FGS Denim Wear Ltd.

30 April 2014

Observations

Structural design of Building 2

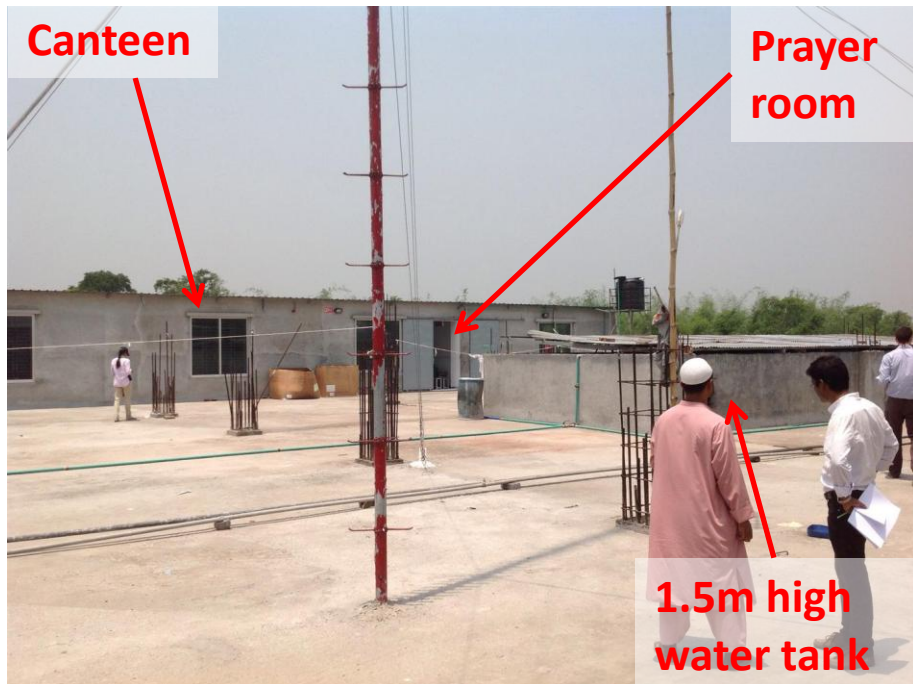
- Members in top boom of truss are not connected at apex of roof.
- Vertical members appear to be tack welded.
- Truss does not appear to be continuous over central support.

- Unclear lateral stability system in Building 2 in east-west direction.
- Unclear connection details between circular steel columns and trusses.

- Unclear lateral stability system in Building 2 in north-south direction.
- No plan bracing apparent in roof.

- Non-engineered trusses at north end of Building 2.
- Diagonal members do not 'node out' with vertical members of truss.

Item No.	Observation	Recommended Action Plan	Recommended Timeline
1	Structural design of Building 2	Building Engineer to review the structural design of Building 2. Particular attention to be paid to i) steelwork connections and design assumptions, ii) lateral stability of the structure in north-south and east-west directions.	6-months
2	Undocumented extension to Building 1	Supporting RC flat slabs, beams and columns to be checked for loads applied, including structures at roof level.	6-months
3	Undocumented extension to Building 1	Check ground floor columns for buckling.	6-months
4	Undocumented extension to Building 1	As-built structural drawings to be updated to include undocumented extensions at roof level.	6-months
5	Concentrated areas of high loading	Building Engineer to develop loads plans for all buildings, accounting for usage, floor build-ups, solid partition walls and areas of concentrated loading.	6-months

Undocumented extensions to Building 1

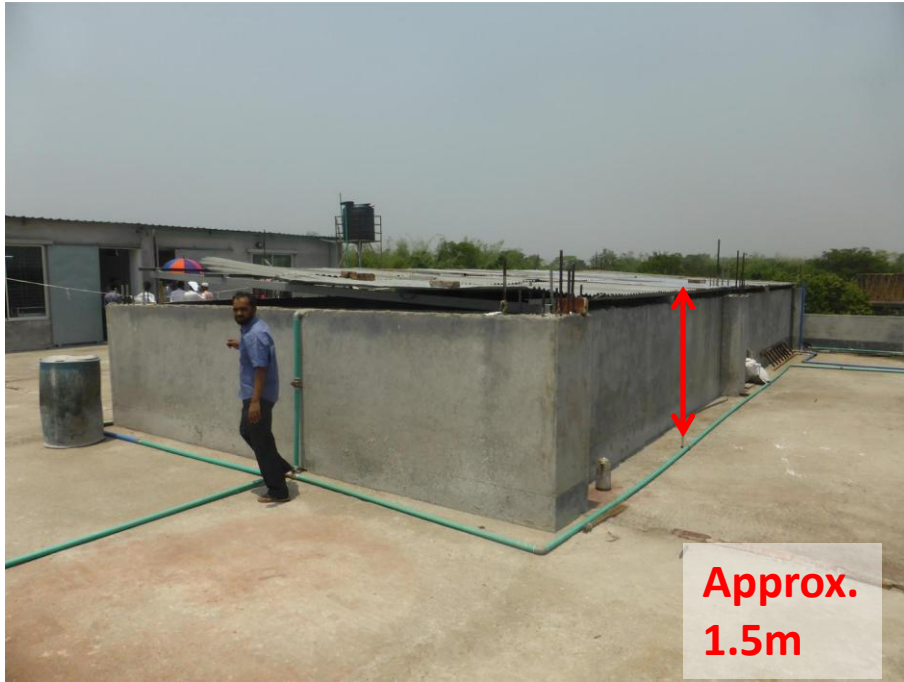
- Canteen and prayer room structures at roof level are not included on permit drawings.
- No structural information was available for these buildings.

Factory management indicate that they intend to add three additional storeys to the building.

- Extension to the East of Building 1 is not included on structural drawings. Factory management indicate that this was built at the same time as Building 1.
- Different floor level observed between Building 1 and extension at 1st floor level.

Concentrated areas of high loading

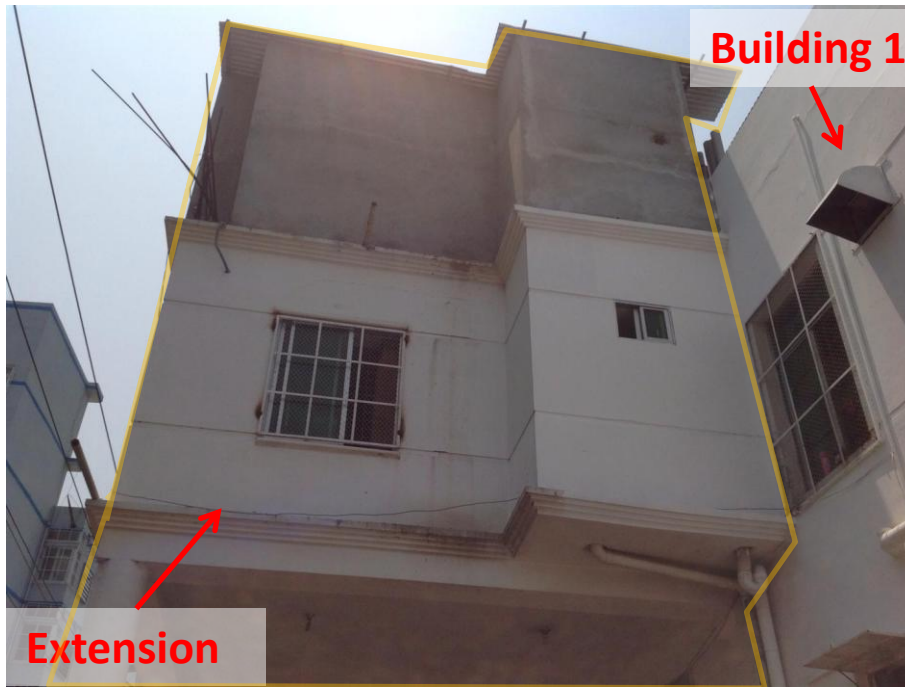
- 1.5m high masonry water tank at roof level. Concrete walls 280mm thick.
- Flat slab construction below, although beam and slab construction indicated on drawings.

- 3no. 2000 litre water tanks provided at roof level.
- Flat slab construction below, although beam and slab construction indicated on drawings.

- Storage area at roof level contains stacked cardboard and boxes.
- No loading management system in place.

6	Concentrated areas of high loading	Building Engineer to verify capacity of existing roof structure (flat slab, beams and columns) to support full water tanks.	6-months
7	Concentrated areas of high loading	Factory management to implement load plans.	6-months

Extension to east of building. View looking south.

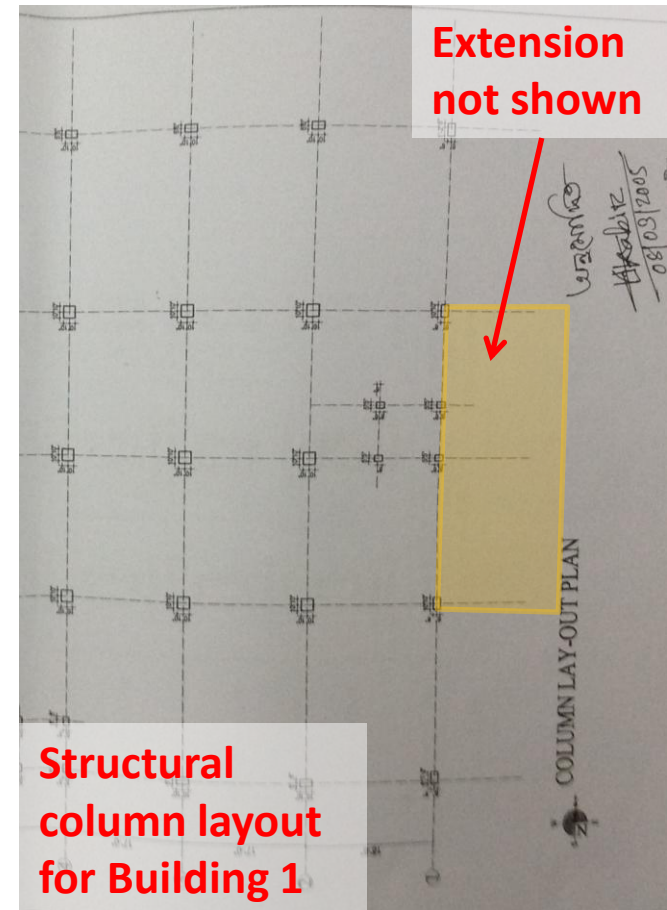
- Two storey extension to Building 1 not indicated on structural drawings.
- Extension is supported by edge columns of Building 1.
- Factory management indicate extension and Building 1 constructed at same time.

Item No.	Observation	Recommended Action Plan	Recommended Timeline
8	Inconsistencies between structural drawings and buildings on site	As-built structural drawings to be generated for all buildings on factory complex, including horizontal and vertical extensions.	6-months
9	Inconsistencies between structural drawings and buildings on site	As-built drawings to be revised as necessary as future modifications or strengthening works are implemented.	6-months
10	Evidence of cracking and damage to structural elements (Building 1)	Building Engineer to identify areas of structural cracking throughout Building 1.	6-months
11	Evidence of cracking and damage to structural elements (Building 1)	Building Engineer to continue to monitor size, length and location of structural cracking throughout Building 1.	6-months
12	Evidence of cracking and damage to structural elements (Building 1)	All future penetrations through slabs and beams to be agreed with Building Engineer.	6-months

General beam arrangement

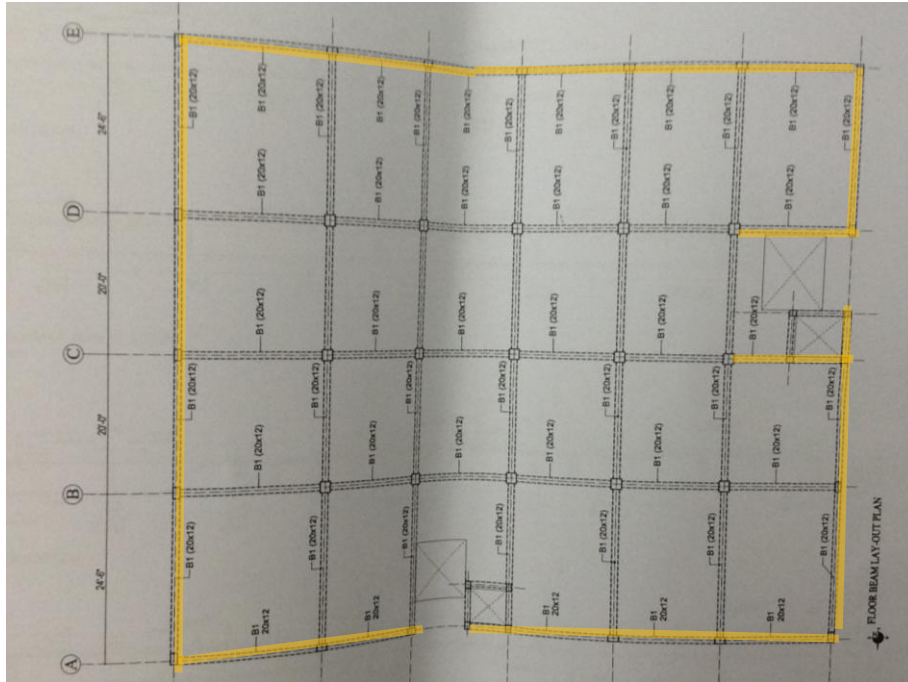
- Structural beam drawing for Building 1 indicates beam & slab construction throughout.
- Flat slab construction observed generally at 1st and 2nd (roof) floors of Building 1.

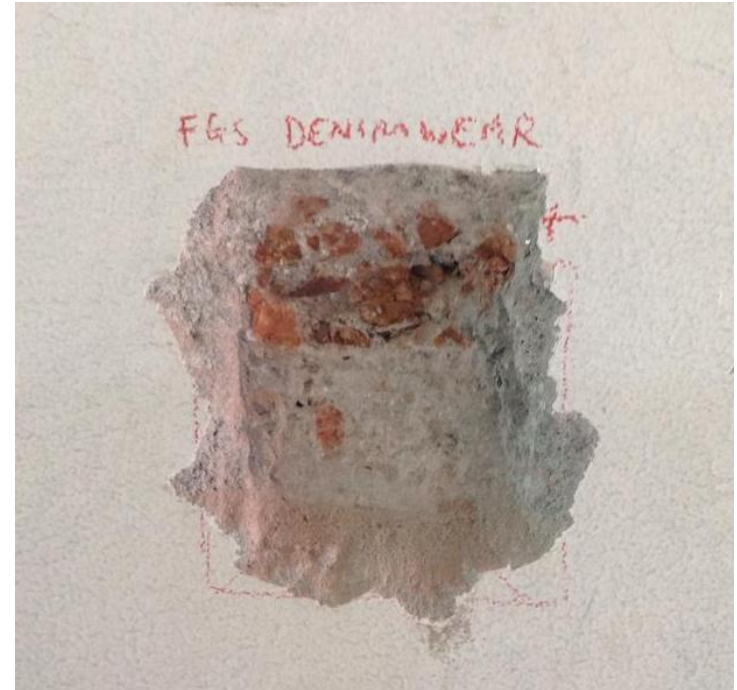
Structural drawings indicate crushed stone chips to be used for all concrete works.

Brick chip aggregate observed in ground floor column on site.

Evidence of cracking and damage to structural elements

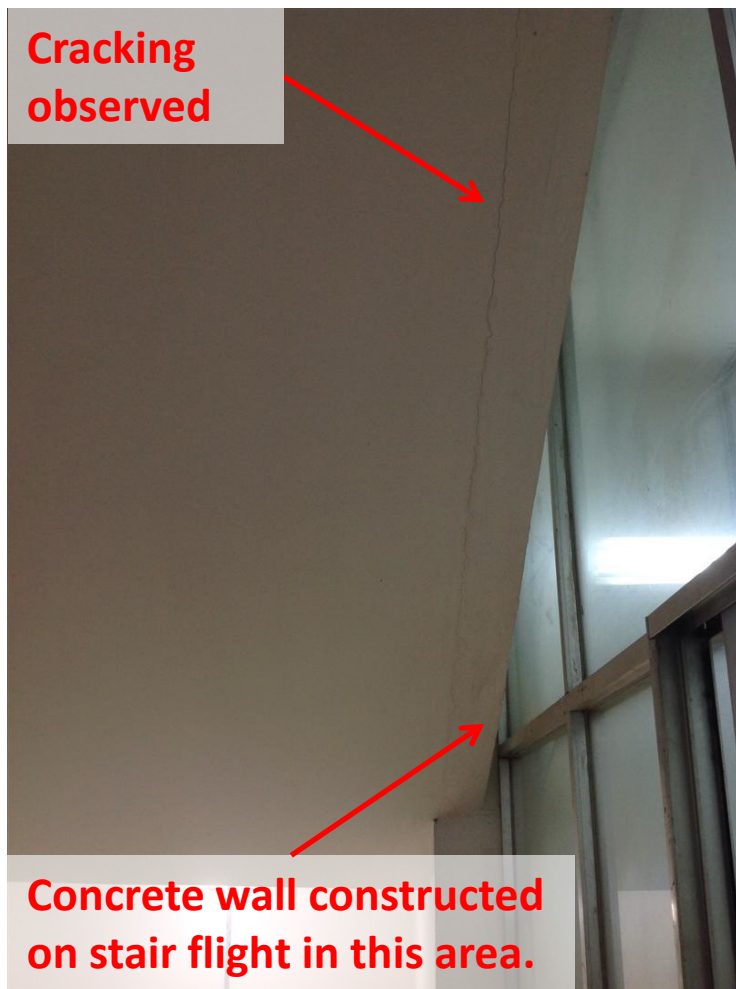
- Cracking observed in stair flight between first floor and roof in Building 1.
- No handrails provided to stair flight up to roof level.
